ISSUE: Permit to Demolish/Capsulate (partial) and Certificate of Appropriateness

225 North Fairfax

Docket #7&8 BAR2023-00401 & BAR2023-00436 Old and Historic Alexandria District November 15, 2023

PRELIMINARY CONCEPT DESIGN DRAWINGS

Figure 2: Proposed dormer centered on the north side of the sloped roof

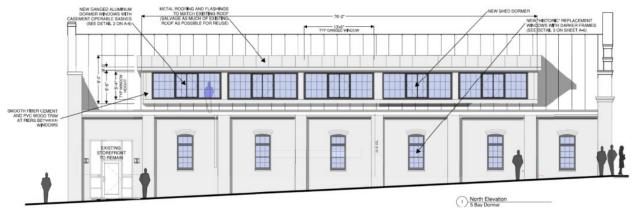
The proposed dormer is aligned with the two outermost piers and is in the lower section of the sloped roof. Centered above each exterior wall bay is a grouping of three multi-lite windows separated by a solid vertical portion aligned with the wall pier below (Figure 2). The applicant is proposing to salvage as much of the roof to be removed as possible for re-installation on the dormer and where this is not possible, the dormer roof will match the main roof in material and configuration. The sides of the dormer will be horizontal fiber cement siding.

Staff recommends the approval of the Certificate of Appropriateness for the proposed dormer but recommends continued study in some areas. The rhythm of the north elevation with the protruding piers and centered single windows sets up the simplicity of the north elevation. Staff recommends that the applicant consider altering the spacing of the windows in the dormer so that the vertical solid sections are widened to align with the piers below. This would also allow for windows to become somewhat more narrow, giving them a vertical proportion similar to the other windows on the building. Staff also finds the proposed used of fiber cement siding on the sides of the dormer to not be compatible with the materials found elsewhere on the building. Staff recommends that the applicant consider alternative materials that would be more subtle and compatible with the overall building.

- 1. The applicant work with staff to revise the spacing of the windows on the dormer to align with the wall piers below.
- 2. The applicant work with staff to identify a material for the sides of the dormer that is more compatible with building materials found elsewhere on the building.

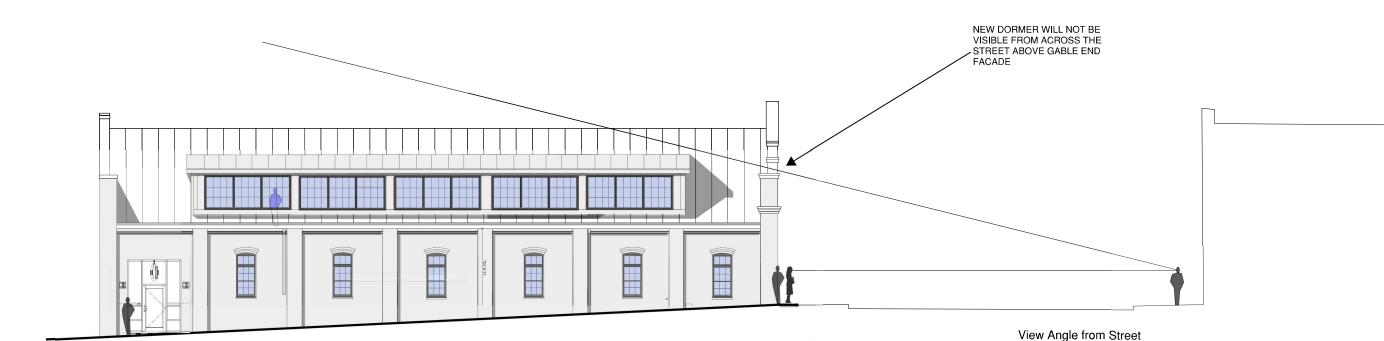
While the proposed dormer will not be visible from North Fairfax Street, it will be highly visible from Queen Street. As previously noted, the existing Queen Street design is more simple than the building façade and is generally utilitarian in nature. The deck at the east side of the building and the storefront entrance at the east end of the north elevation are both modern interventions into this building that were approved by the BAR. The design of the proposed dormer includes five bays of three ganged, square windows with a vaguely industrial design motif that is consistent with the original use of the building as an automotive garage. The use of a standing seam roof similar to the roof on the main building is compatible with the overall design. The use of fiber cement siding on the east and west sides of the dormer are somewhat discontinuous with building materials found elsewhere on the building.
